UNITED STATES PATENT AND TRADEMARK OFFICE

APPLICATION NO.	FILING DATE	FIRST NAMED INVENTOR	ATTORNEY DOCKET NO.	CONFIRMATION NO.
10/511,028	12/09/2004	Ian Boast	ENL-345-A	8758
7590		07/17/2007		
Andrew R Basile				
Young & Basile				
3001 West Big Beaver Road				
Suite 624				
Troy, MI 48084				
			EXAMINER	
			SELF, SHELLEY M	
			ART UNIT	PAPER NUMBER
			3725	
			MAIL DATE	DELIVERY MODE
			07/17/2007	PAPER

Office Action Summary

DETAILED ACTION

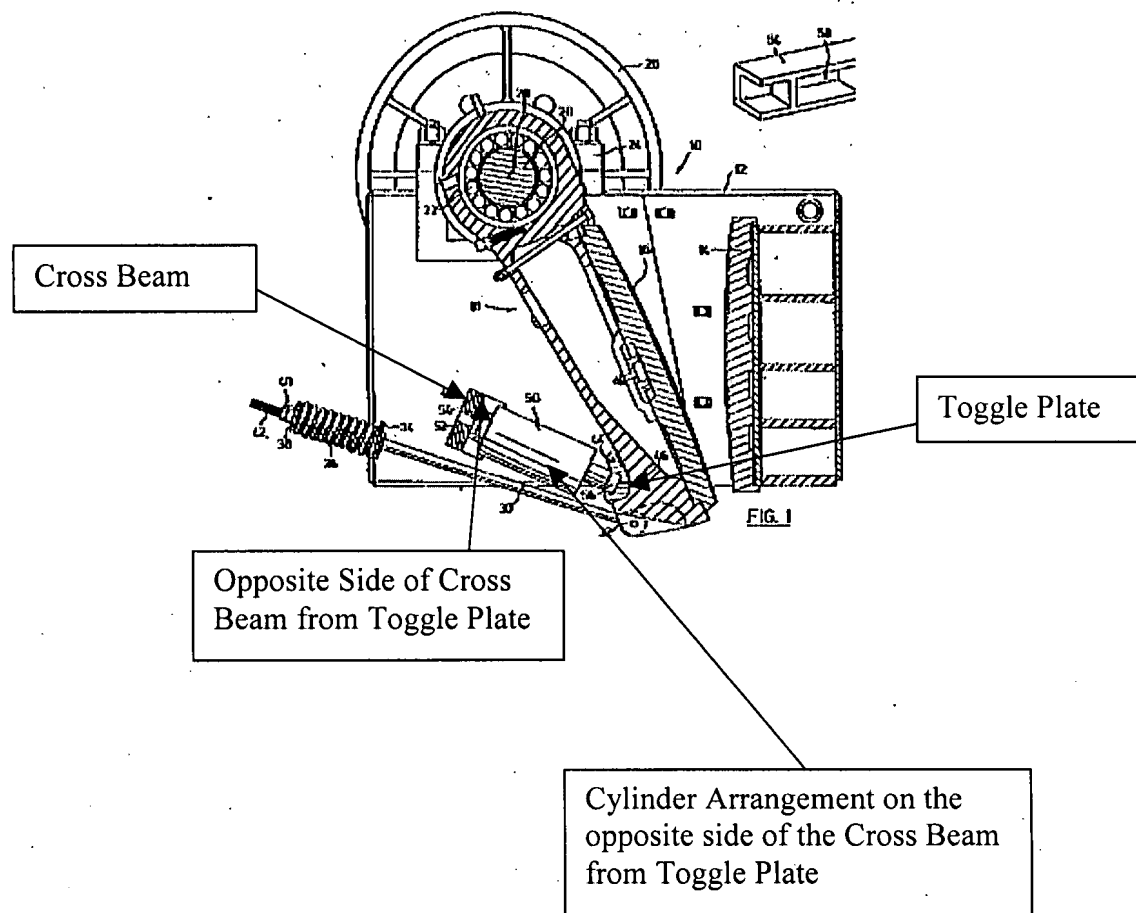
Applicant's arguments filed April 27, 2007 have been carefully considered but they are not persuasive. Applicant's remarks are drawn to the failure of the prior art, Altmayer to disclose a hydraulic cylinder arrangement on the opposite side of the cross beam from the toggle plate. Applicant argues instead that Altmayer teaches the a hydraulic cylinder arrangement (50) arranged intermediate to the toggle plate (44) and therefore not opposite of the cross beam. This argument is not found persuasive, because Altmayer clearly discloses a cross beam (48) that is opposite of the a toggle plate (44), the cross beam (48) having an opposite or opposing side to the toggle plate (44), Altmayer further discloses cylinder arrangement (50) attached or operably coupled to that side of the cross beam that is opposite of the toggle plate.

Although it is Altmayer's inner surface of the cross beam (48) that is opposite of the toggle plate there is no structure within the claimed invention that prohibits the cylinder arrangement from being operably attached at this opposite side, i.e., intermediate. Accordingly, Altmayer discloses the claimed invention and a rejection in view of Altmayer is made.
